# UNITED STATES PATENT AND TRADEMARK OFFICE

APPLICATION NO.	FILING DATE	FIRST NAMED INVENTOR	ATTORNEY DOCKET NO.	CONFIRMATION NO.
10/802,984	03/17/2004	Donald R. Van Der Moere	D5270	3898

# Office Action Summary

## **DETAILED ACTION**

**FIG. 1**  
PRIOR ART

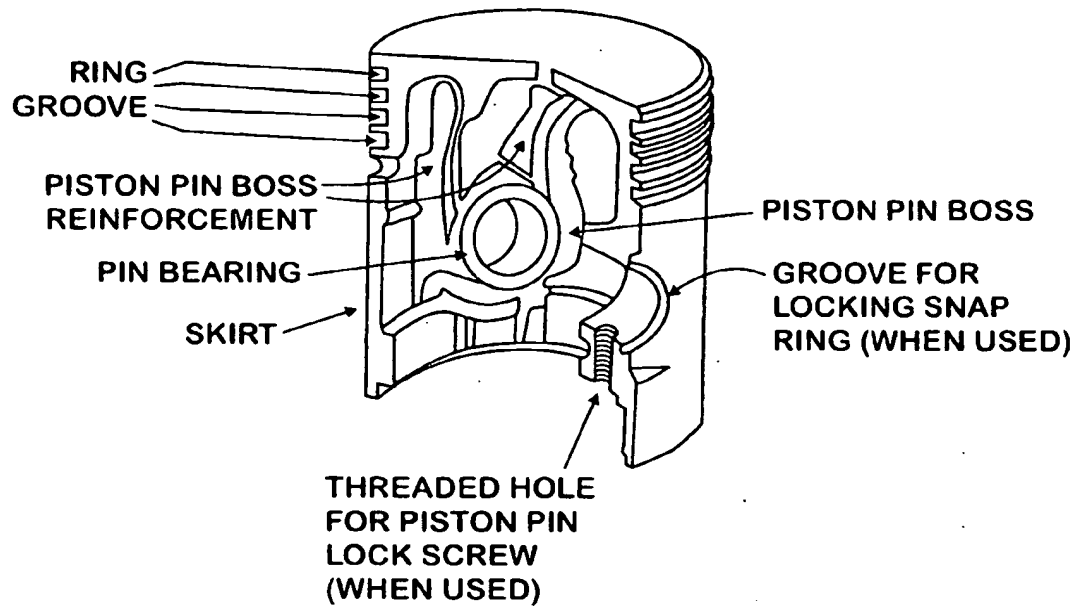
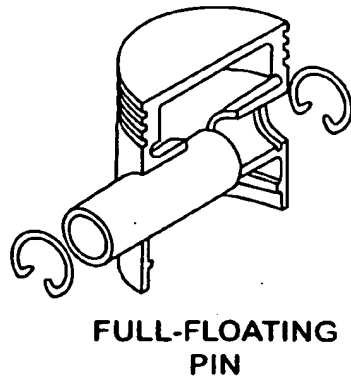
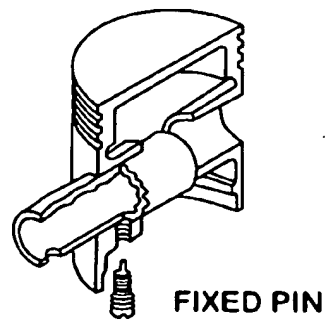
The drawings were received on September 28, 2004. These drawings are not acceptable. The drawings do not comply with 37 CFR 1.121 because the top margin of each sheet has not been identified as "Replacement Sheet".

not accepted  
92. 8/4/05

**FIG. 2**  
PRIOR ART**FIG. 3a**  
PRIOR ART**FIG. 3b**  
PRIOR ART

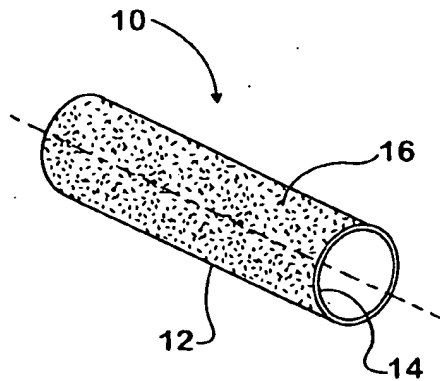
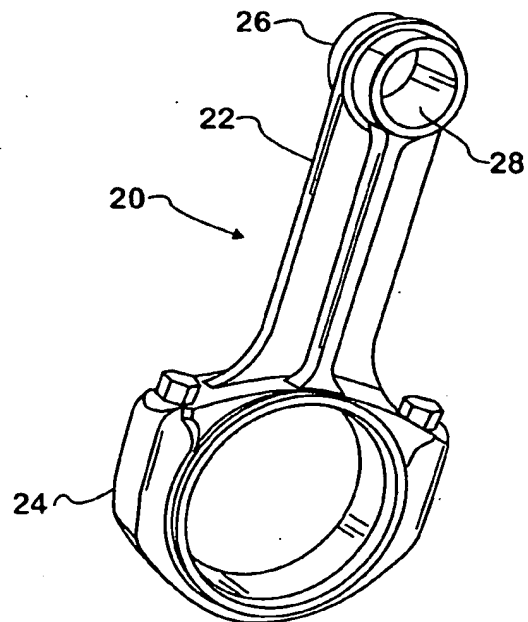
not accepted  
EL. 8/4/05

**FIG. 4****FIG. 5**

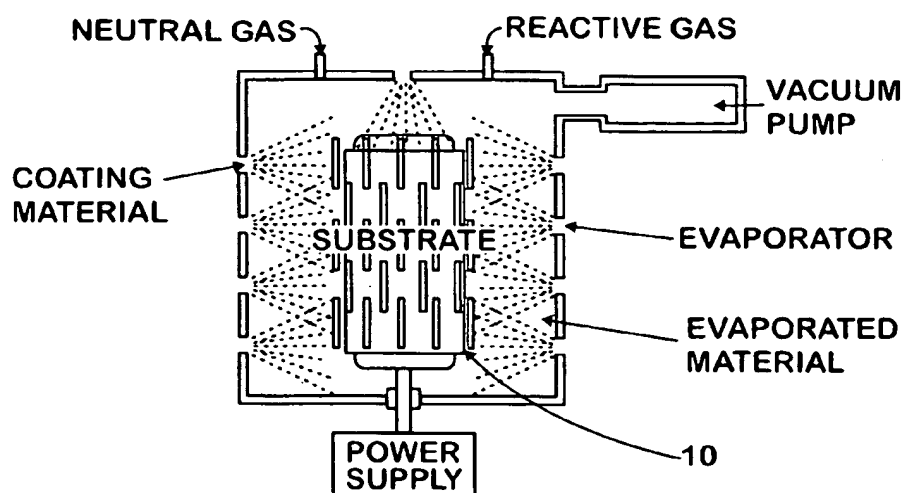
not accepted  
E.L. 8/4/05

FIG. 7

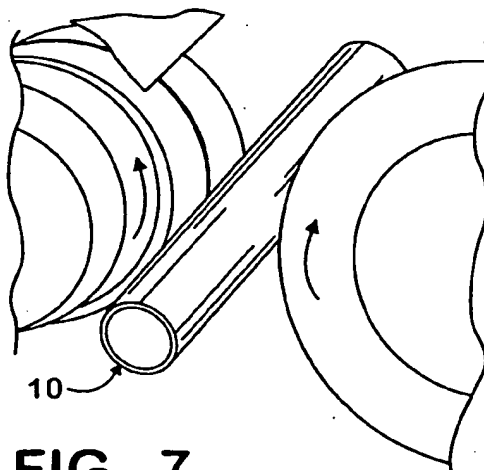
not accepted  
E.L. 8/4/05
